Countries:	CANADA, UNITED STATES	Document ID:	IK0900128
Availability:	ISIS, Fleet!SIS, Body Builder, NotSIR	Revision:	0
Major System:	COOLING	Created:	6/20/2018
Current Language:	English	Last Modified:	6/25/2018
Other Languages:	NONE	Author:	Bobby Christopher
Viewed:	123

Title: Evaporator freeze up

Applies To: All Horizon Family (LT,RH, MV/HV) built before 5/25/18

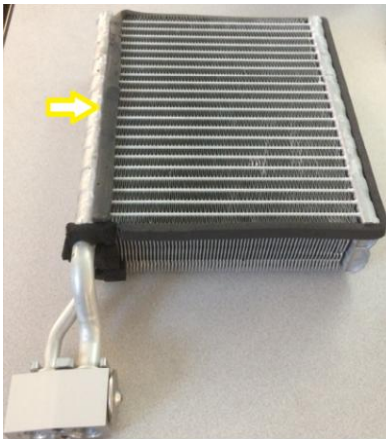
1. Remove evaporator, following steps in Master Service Information and relocate evaporator seal as shown.

1. Inspection: Incorrect seal location

1. Correct seal location
